PROPOSED SELF STORAGE FACILITY - WILSON STORAGE

LOT 100, DP 615225
9-13 COOK STREET, FORESTVILLE NSW 2087

SECTION 4.55 SUBMISSION
04 MARCH 2020

Drawing Title
BUILDING ELEVATIONS
A1 Scale
1 : 200
A3 Scale
HALF A1 SCALE
Date
05.12.2019
Drawn
CR
Drawing No
19-029 DA301
Revision
C

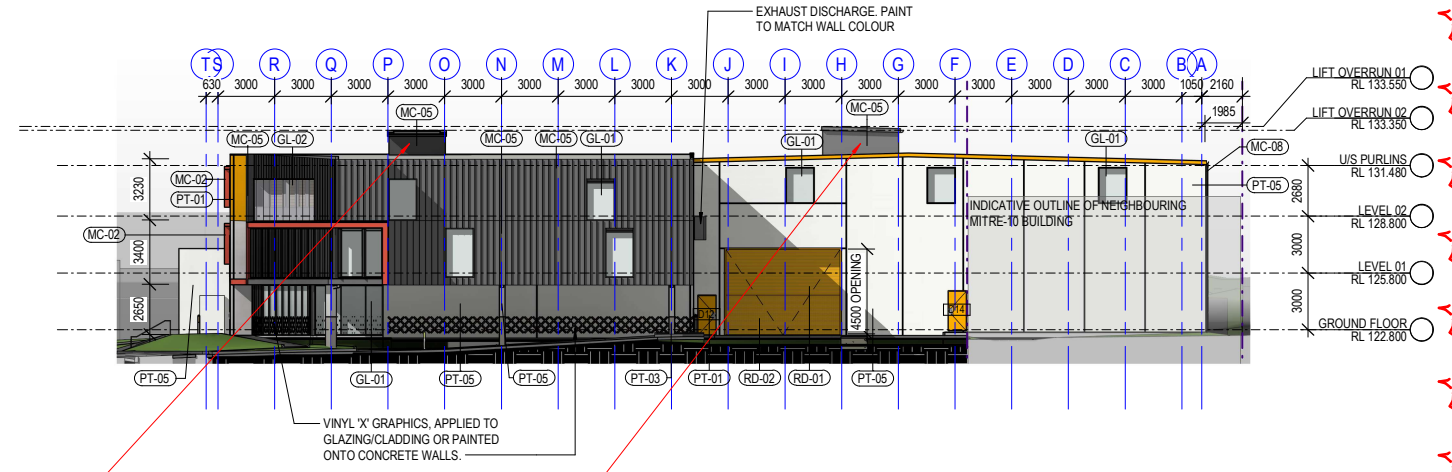
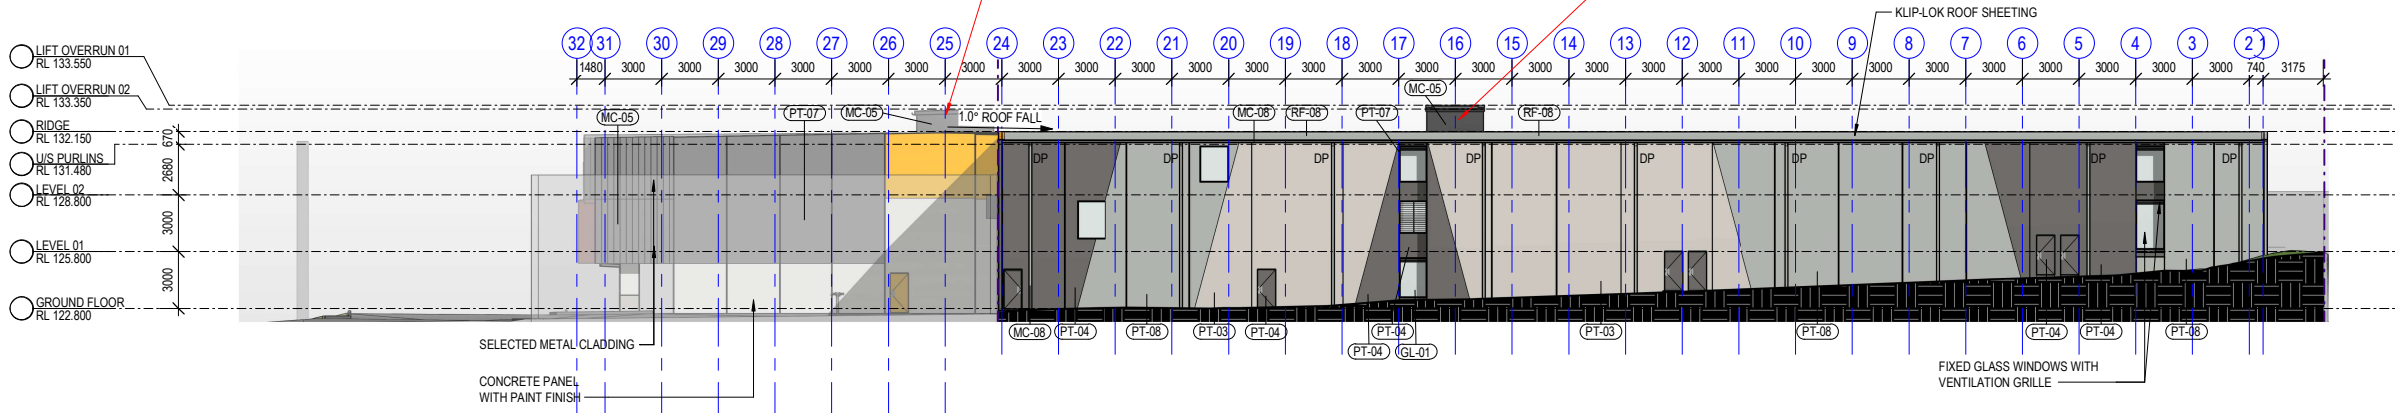
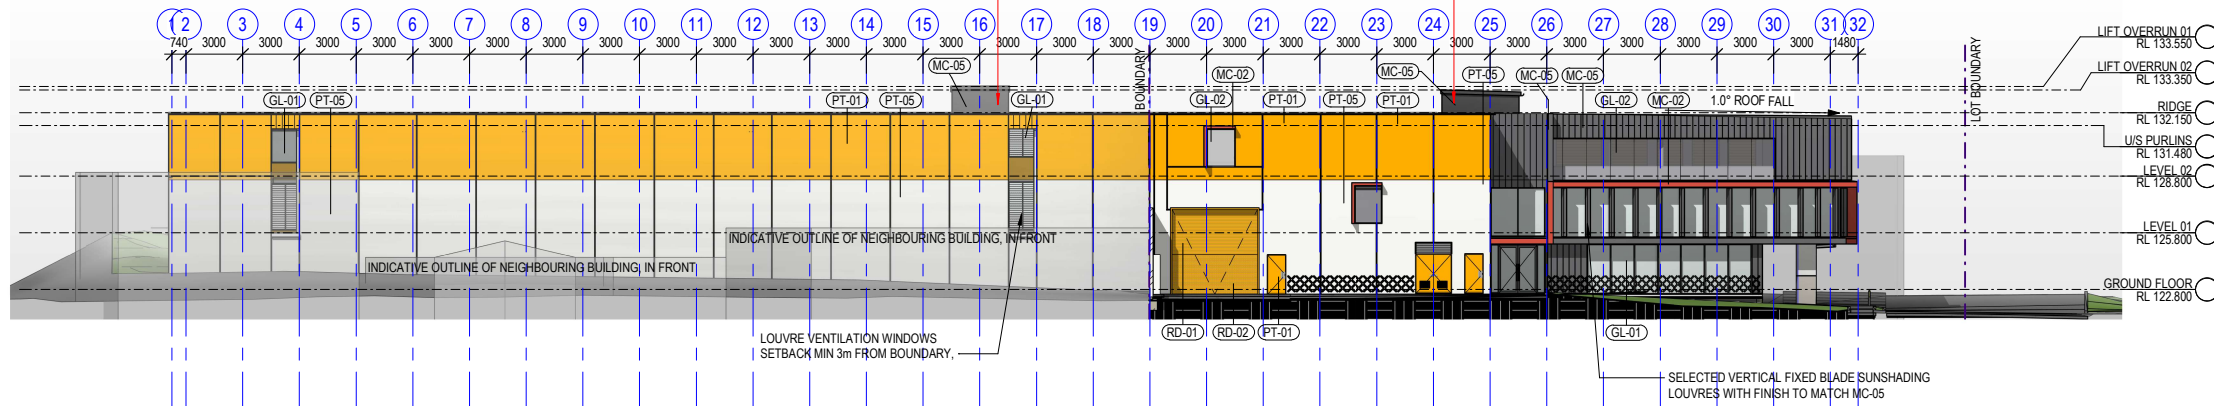
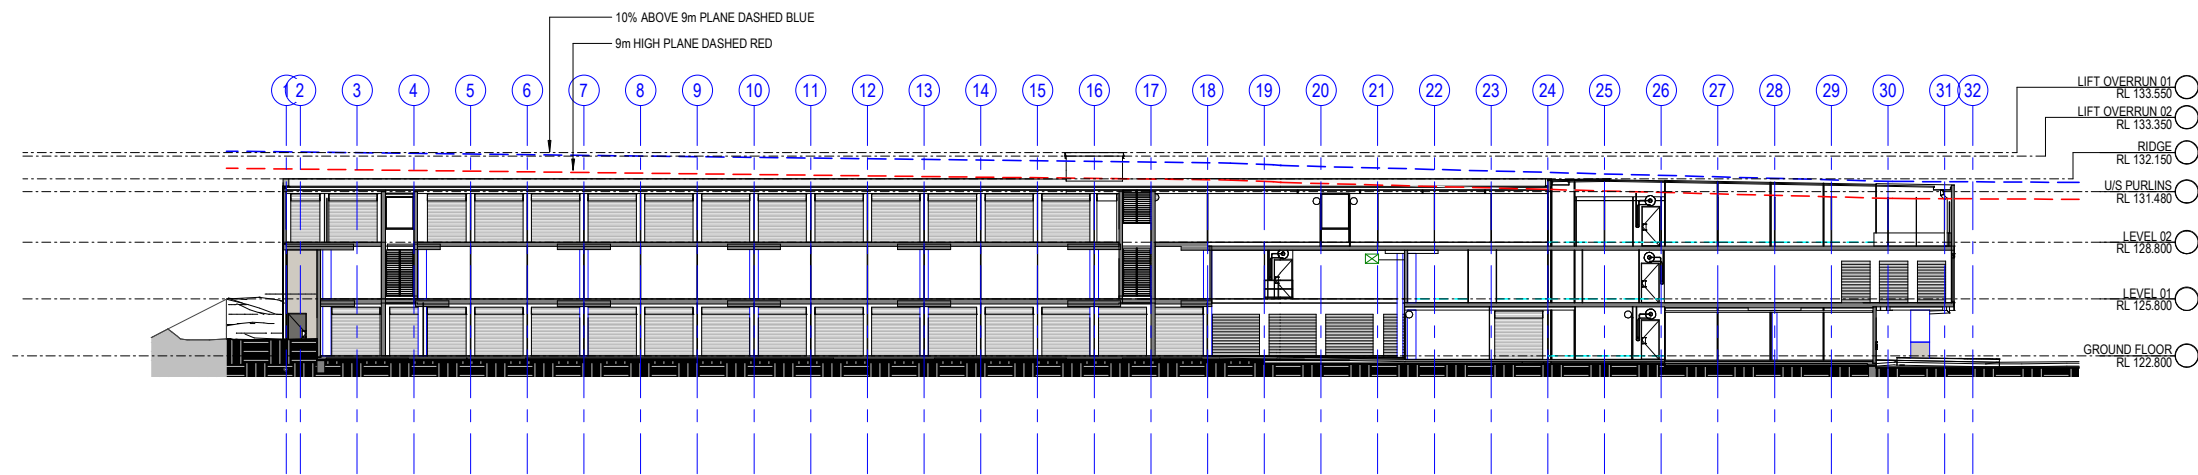
LIFT OVERRUNS NOMINATED
AS PART OF THIS SECTION
4.55 APPLICATION

LIFT OVERRUNS NOMINATED
AS PART OF THIS SECTION
4.55 APPLICATION

EXTERNAL BUILDING APPEARANCE
AND COLOURS MODIFIED, AS PART
OF THIS SECTION 4.55 APPLICATION

Drawing Title BUILDING SECTIONS			
A1 Scale 1 : 200	A3 Scale HALF A1 SCALE	Date 08.12.2019	Drawn CR
Drawing No 19-029 DA305			Revision C

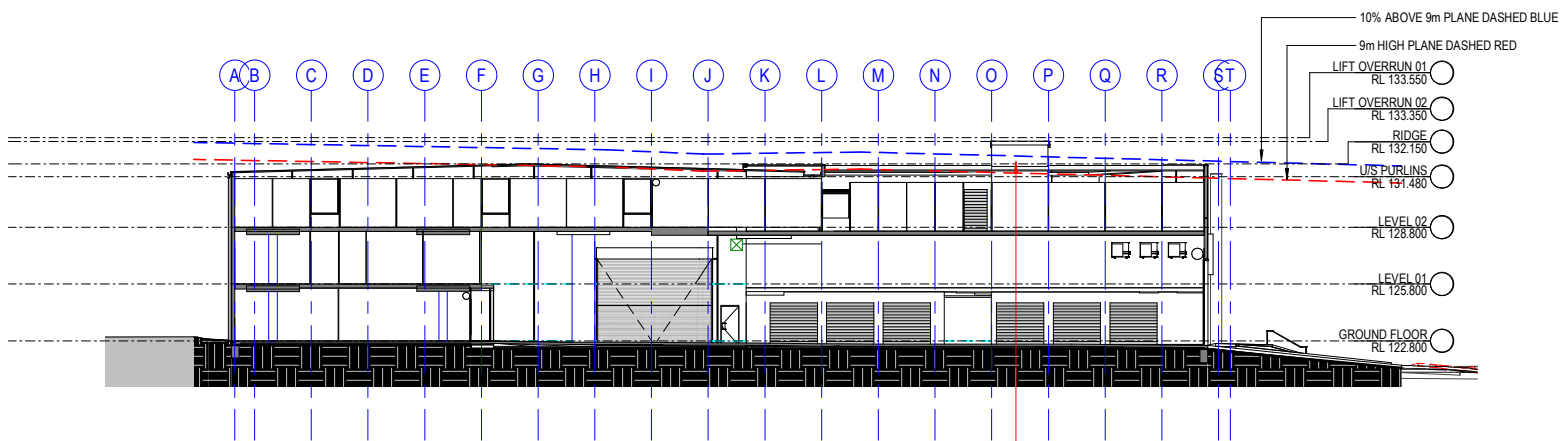
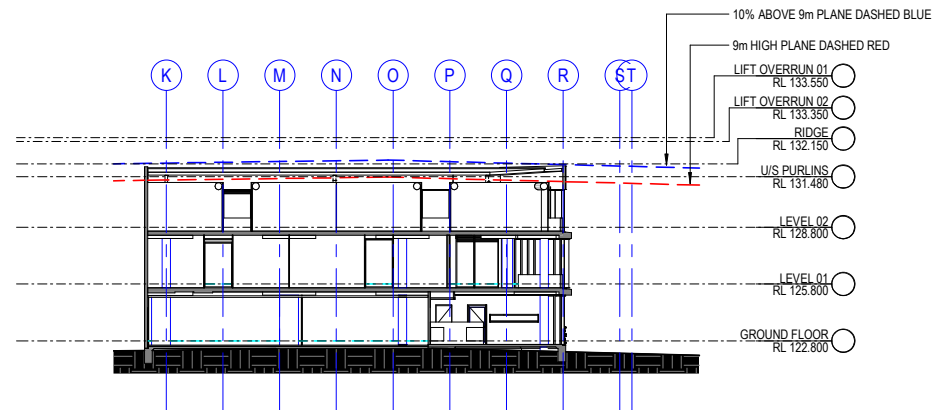
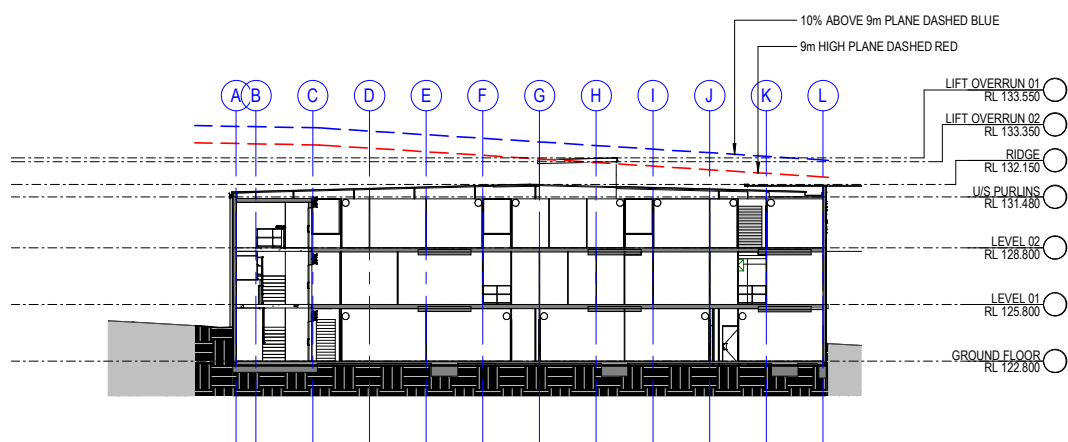
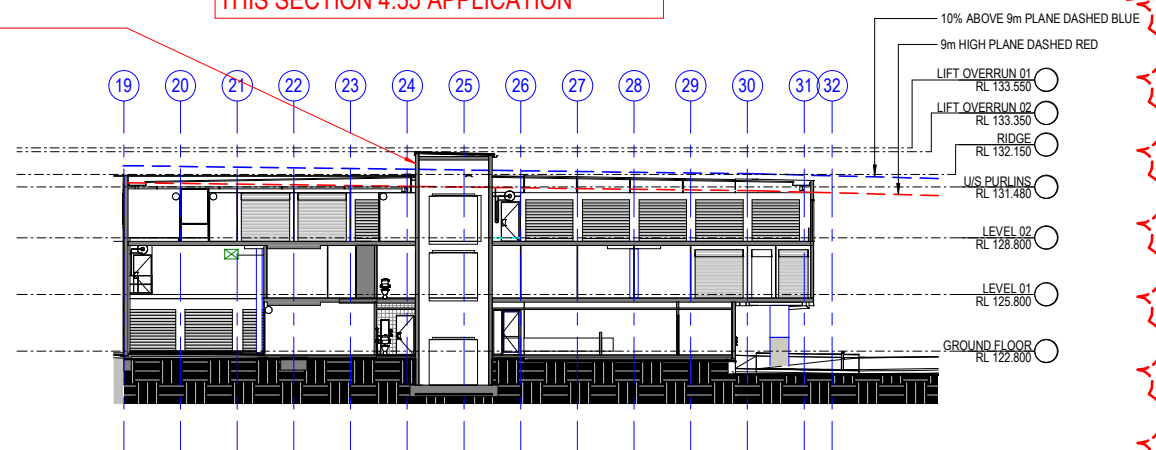
LIFT OVERRUNS NOMINATED
AS PART OF THIS SECTION
4.55 APPLICATION

SECTIONS REVISED TO SUIT BUILDING
LAYOUT MODIFICATIONS, AS PART OF
THIS SECTION 4.55 APPLICATION

A1 Scale 1 : 500	A3 Scale HALF A1 SCALE	Date 06.12.2019	Drawn CR
Drawing No 19-029 DA401			Revision C

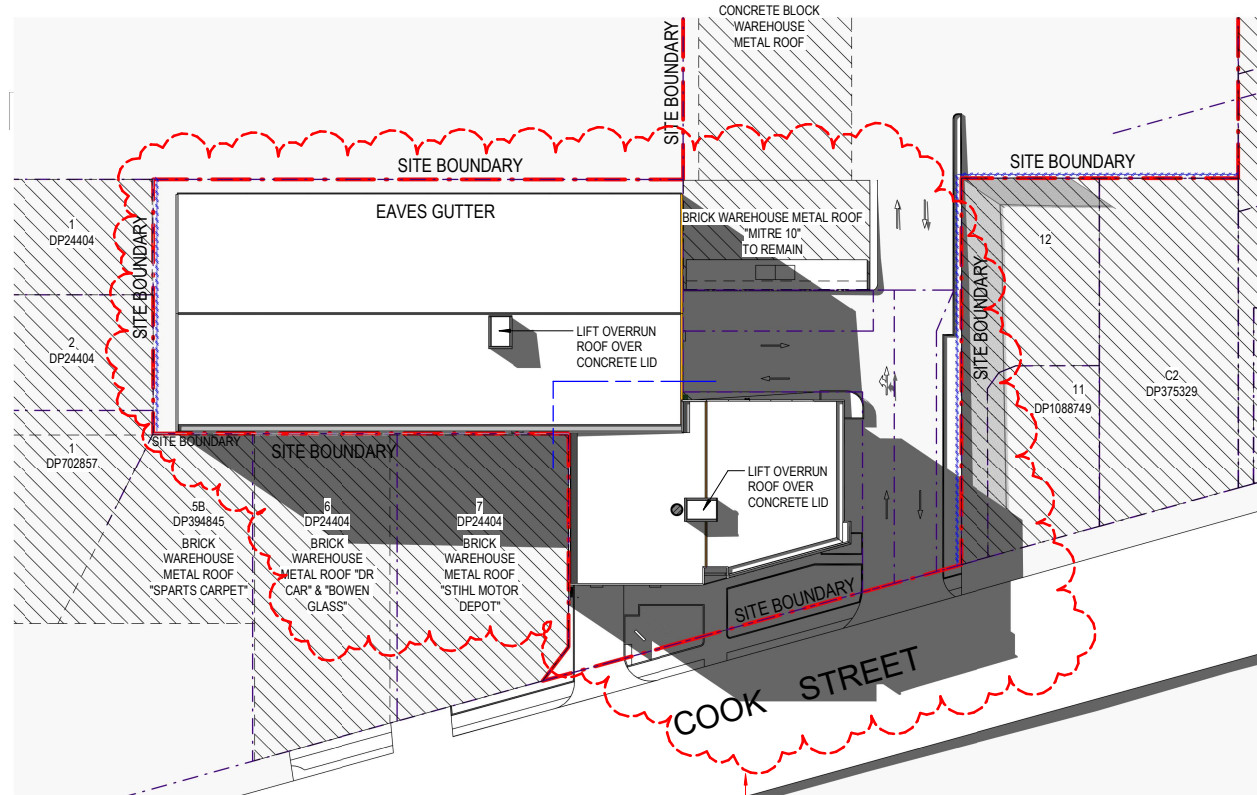
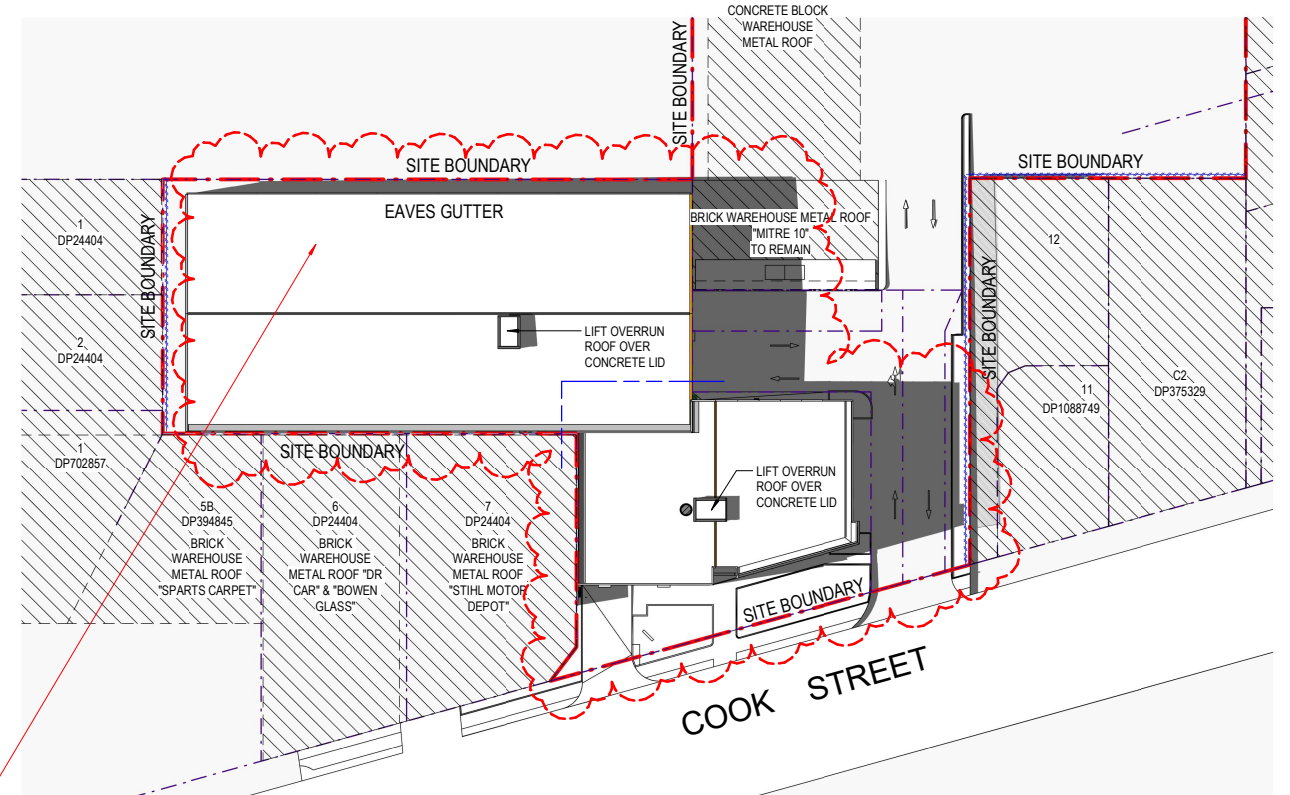
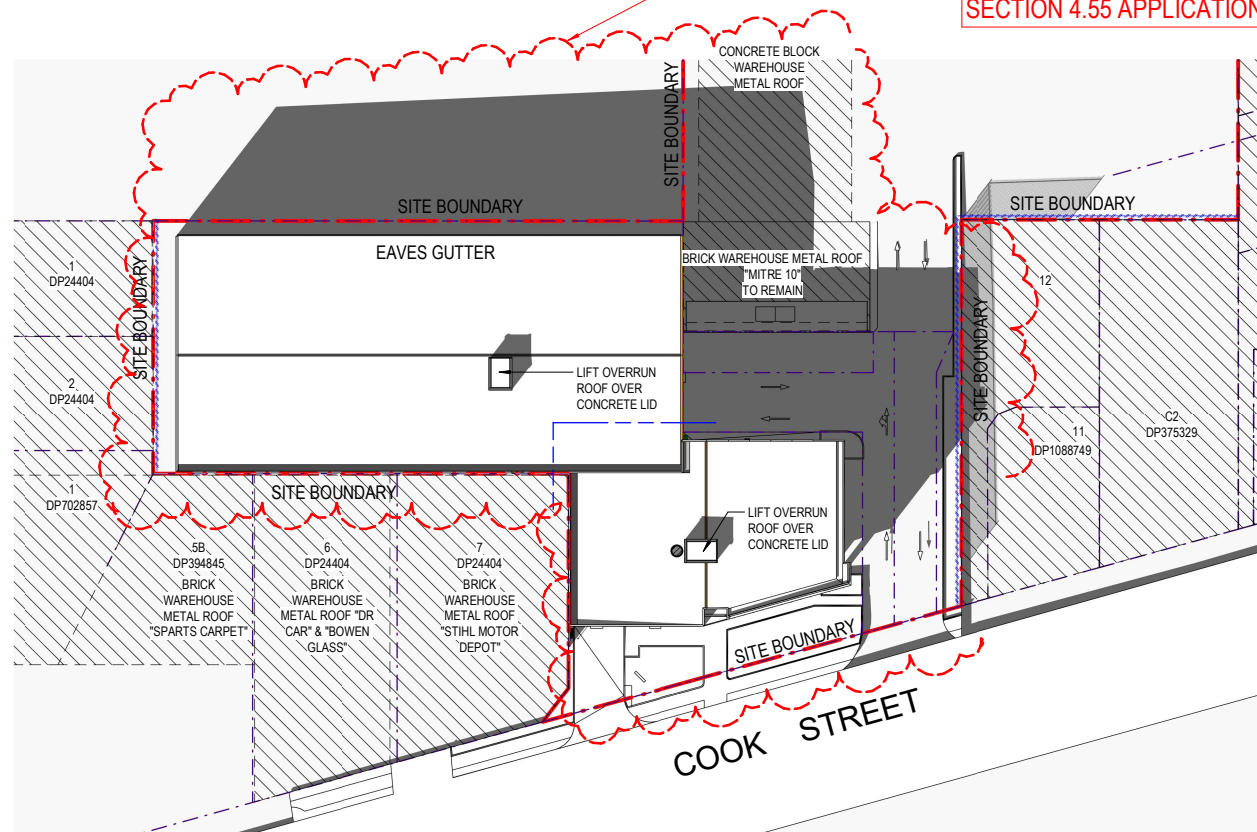
ENTENT OF SHADOWING
REVISED AS PART OF THIS
SECTION 4.55 APPLICATION
